From: Amanda Scholes on behalf of Planning.Responses
Sent: 23 February 2021 08:33
To: Planning Scanning
Subject: FW: Flamsteed - BN/2/21/DOC

From: Finlay Gardner <Finlay.Gardner@arun.gov.uk>
Sent: 22 February 2021 15:37
To: Planning.Responses <Planning.Responses@arun.gov.uk>
Subject: FW: Flamsteed - BN/2/21/DOC

Attenuation Tank Plan

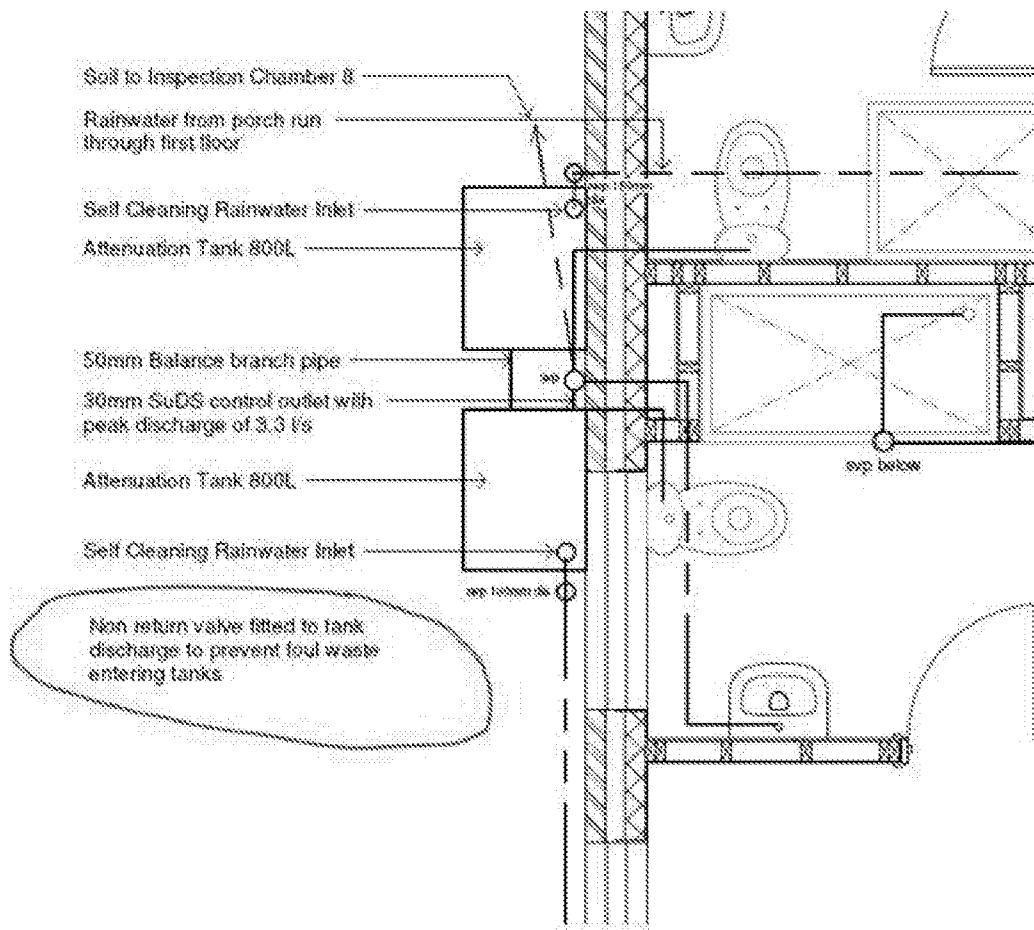
1. The rain-activ attenuation/filter system is the first I have seen specified and it seems to take account of blockage risks and mitigates for it. Maintenance does form part of that mitigation so is important. I therefore have no objection to its use. Just one question though; where the tank connects to the soil vent pipe, what is preventing the risk of foul waste finding its way into the tanks, from the foul waste that discharges into the SVP from the upper floors/s. Is there a non-return valve incorporated on the tank outlet?

1. Drawing Plan D103 shows annotation of non return valve.
